Project Name: Taco Bell (Bogie Lake Road & Highland Road)

Description: Preliminary Site Plan Approval

RE: Taco Bell Preliminary Site Plan Review – 1st Review

Subject: Taco Bell
Preliminary Site Plan Review #2
Zoned: Planned Business (PB) District

C5.0

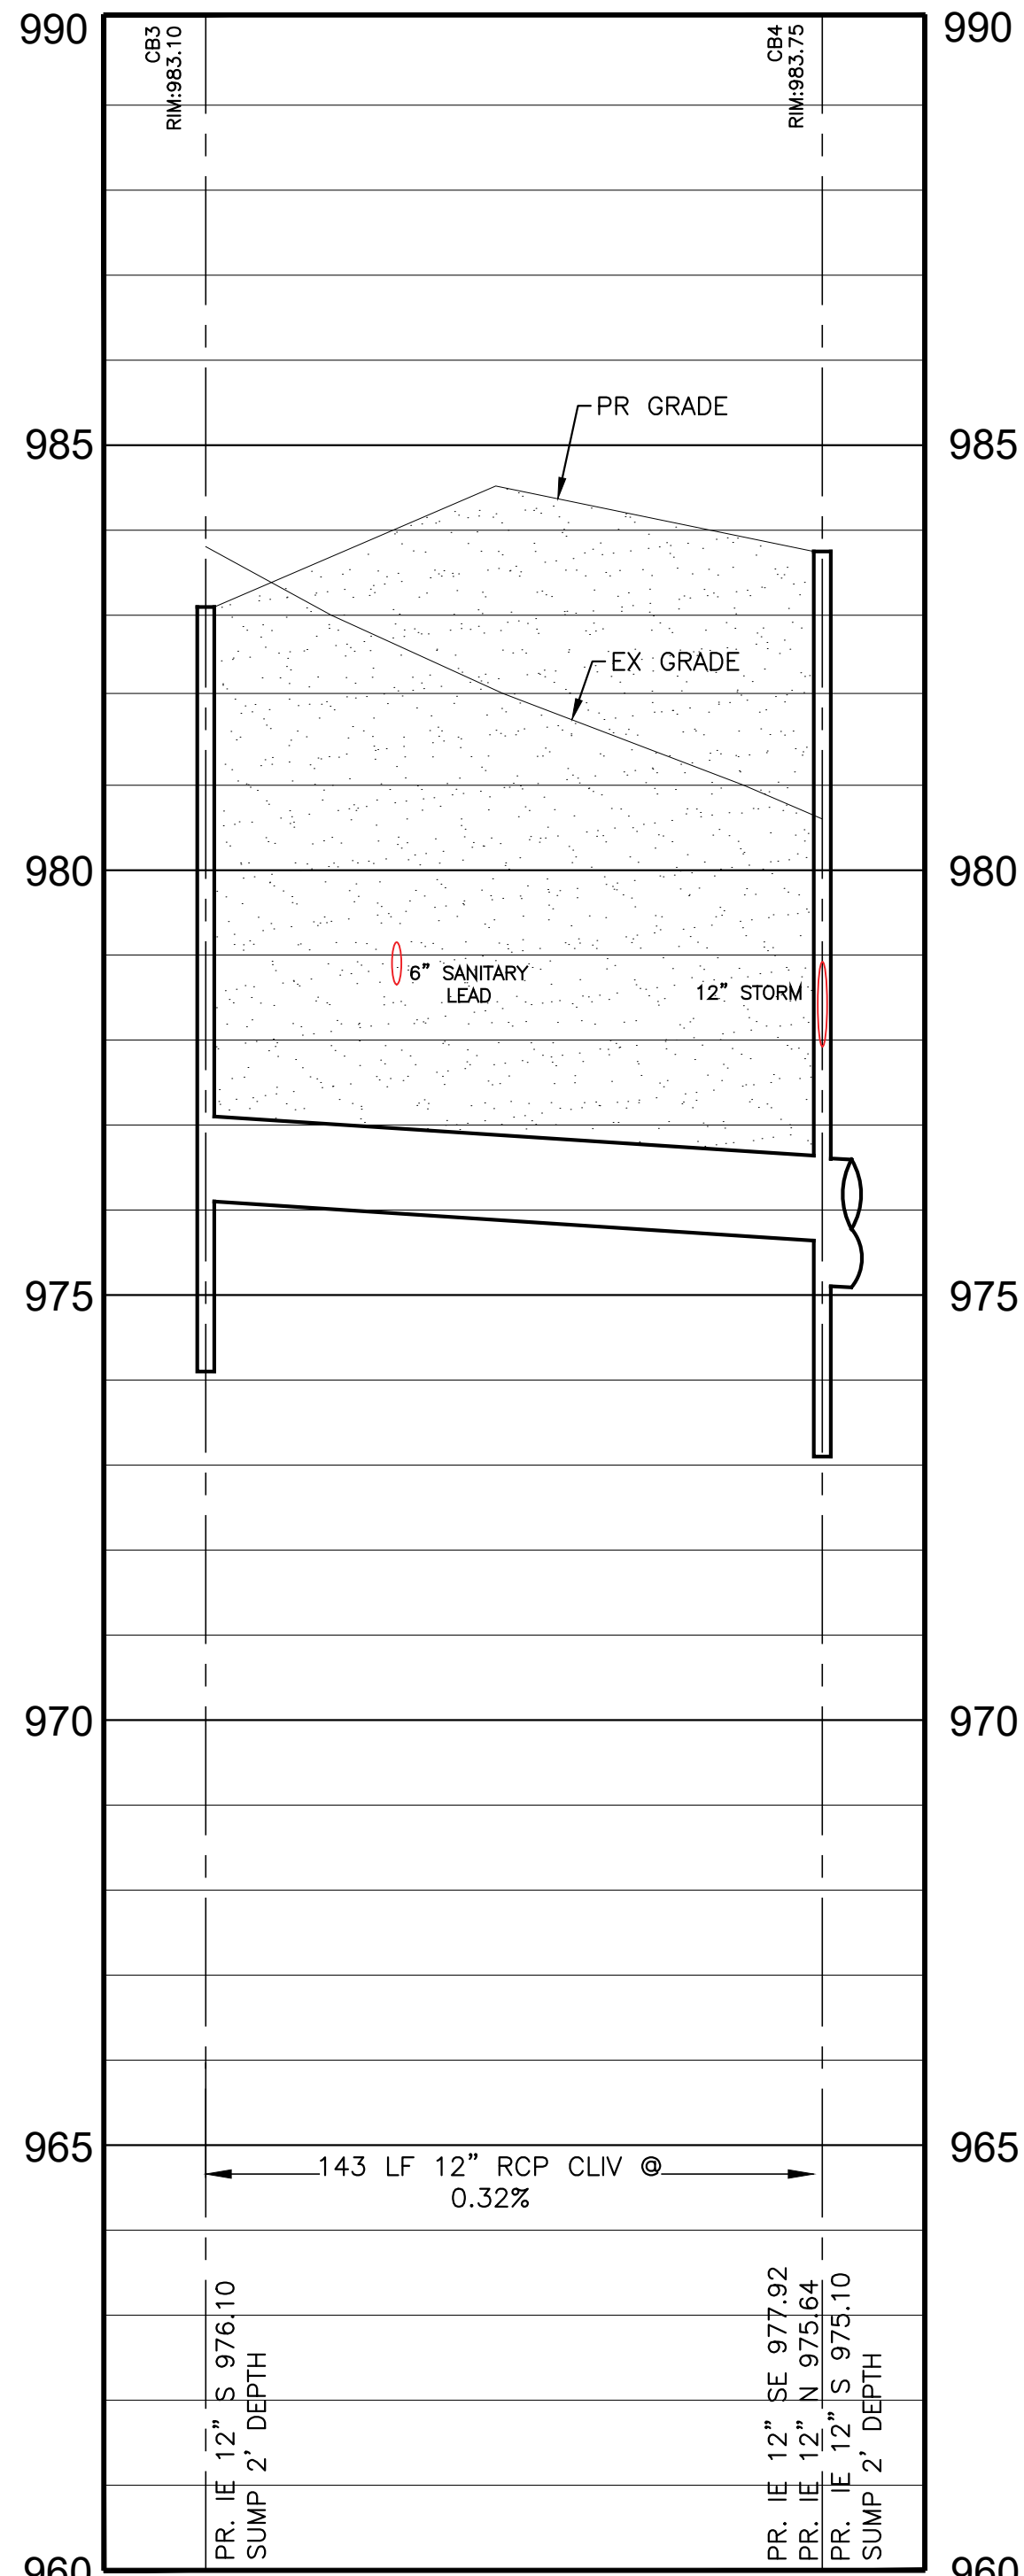
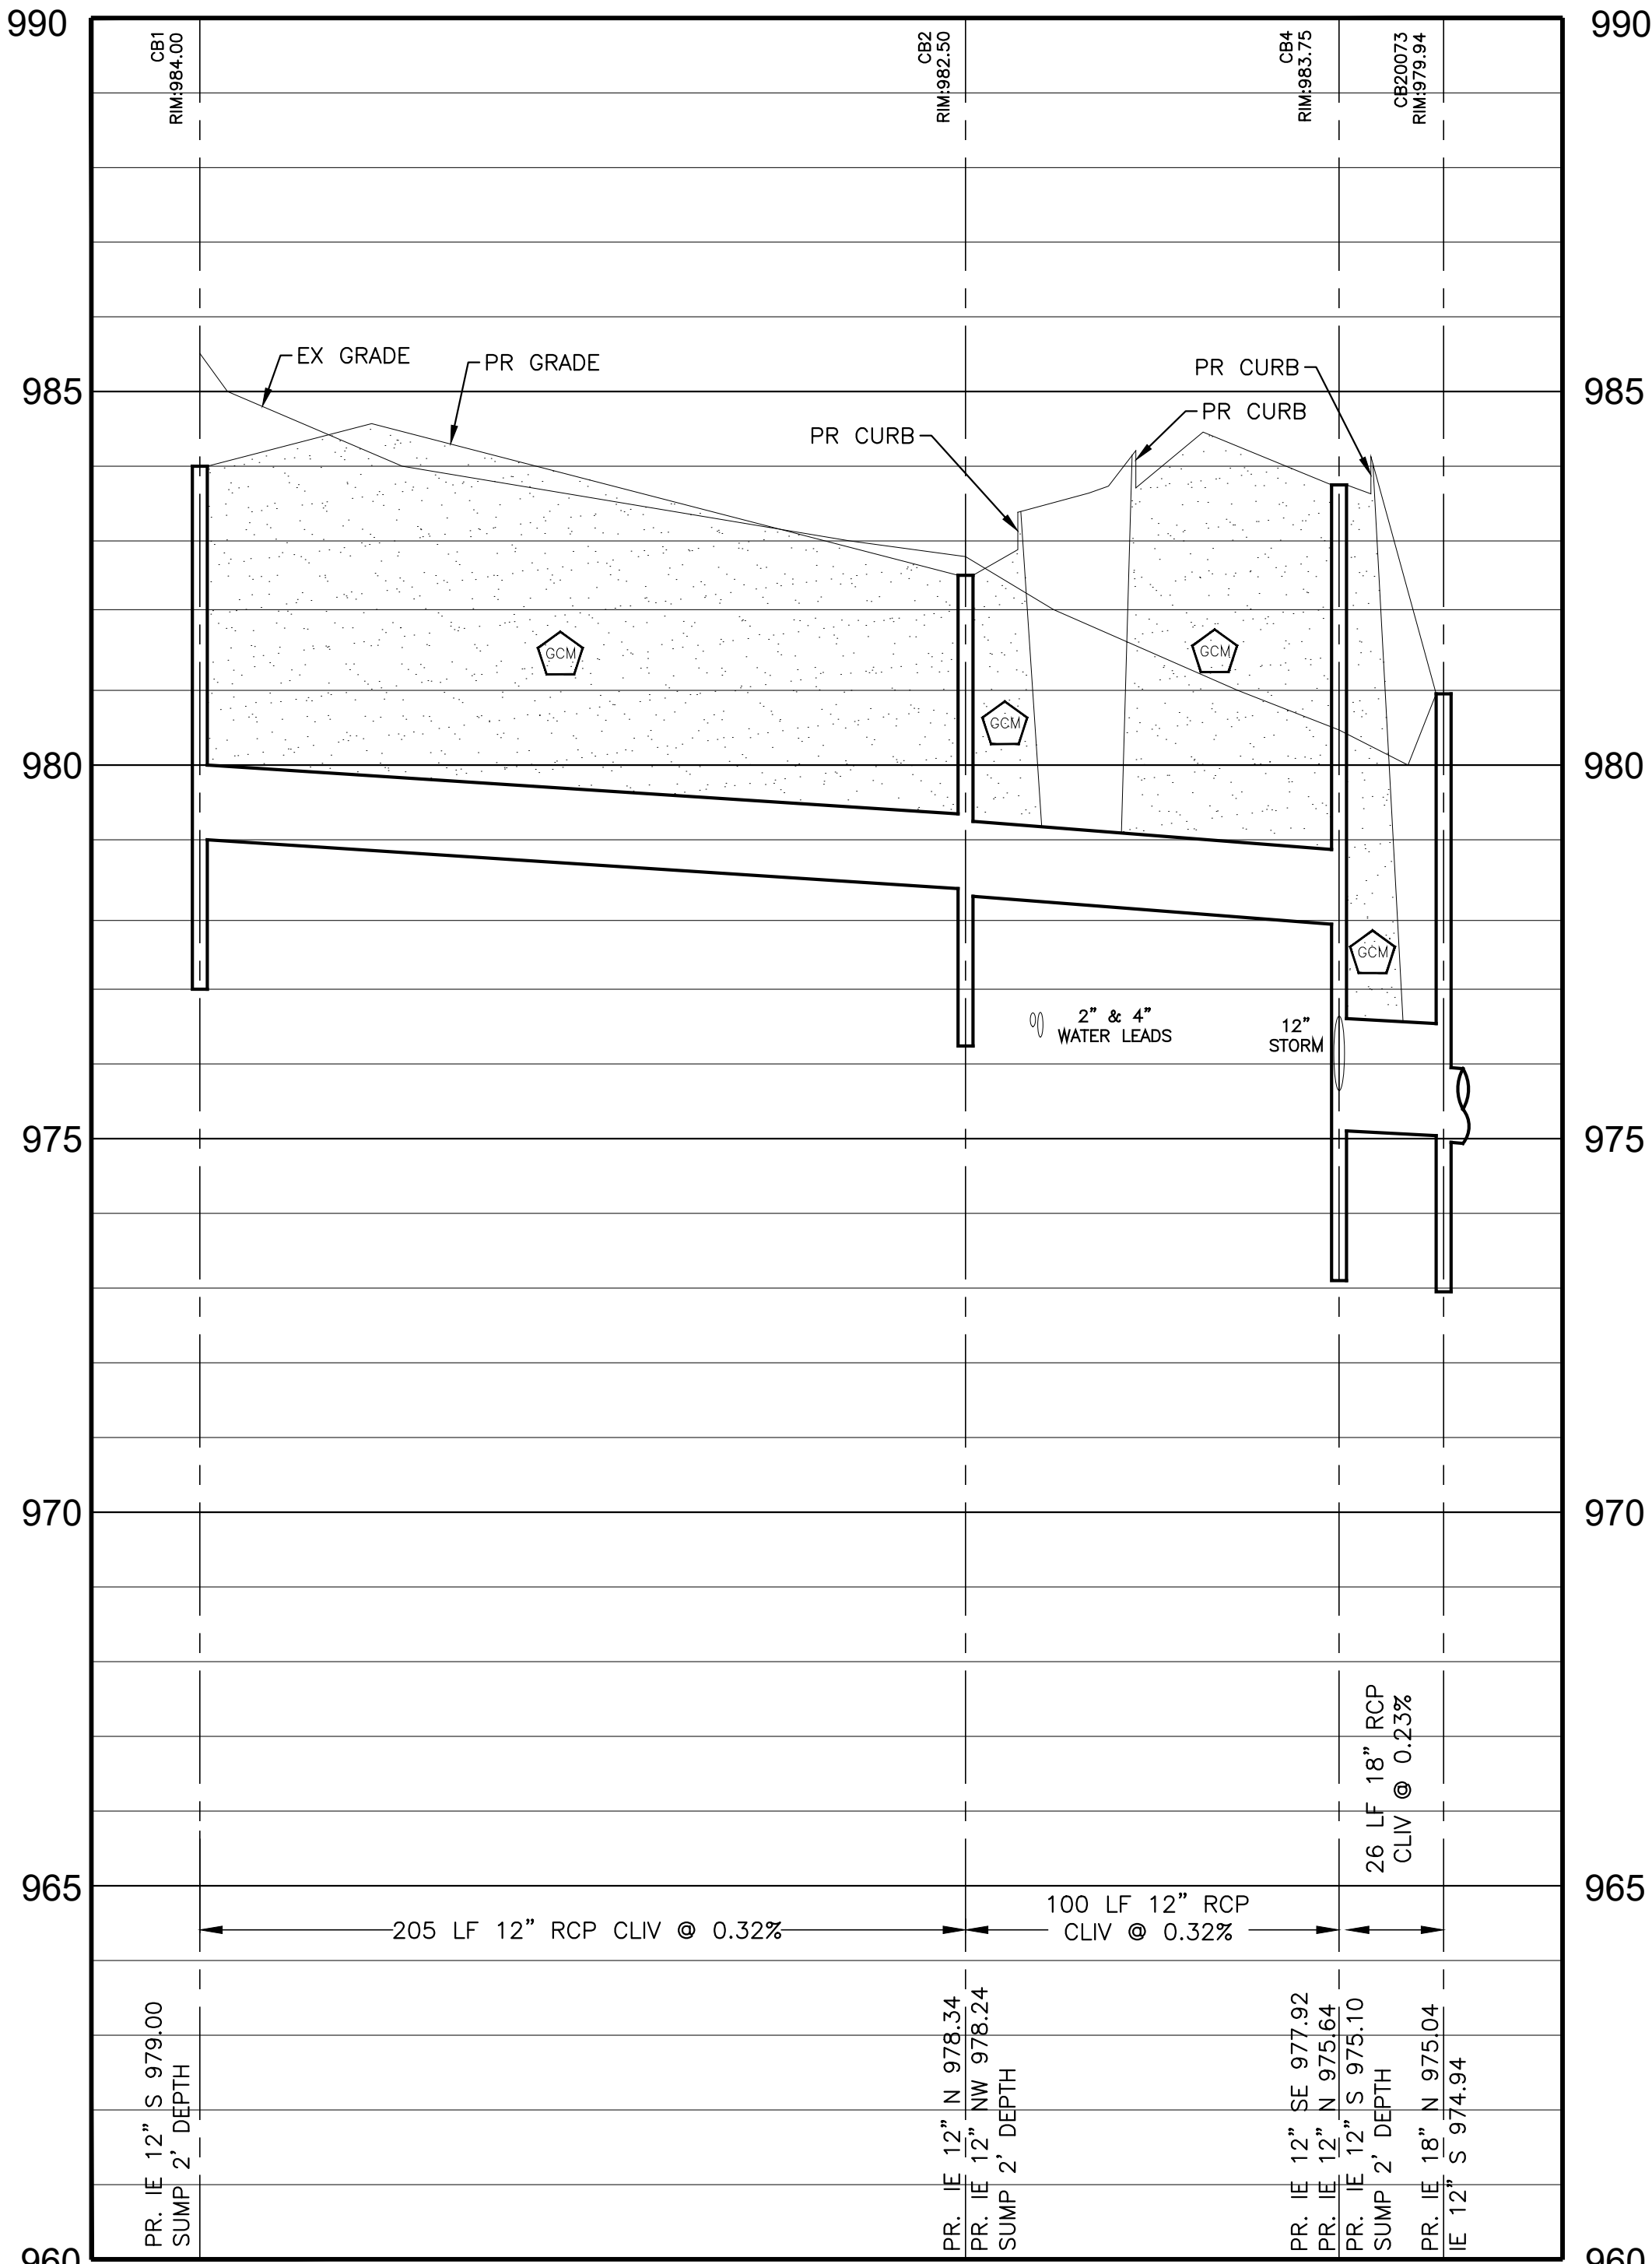
Note 11 on sheet C5.0 indicates that the Township shall connect services 2 inch and smaller. While the Township can provide the connection, an 20 % admin fee will be charged per ordinance. It will usually be less expensive for the developer to use their own properly licensed and bonded contractor for the connection which we will inspect.
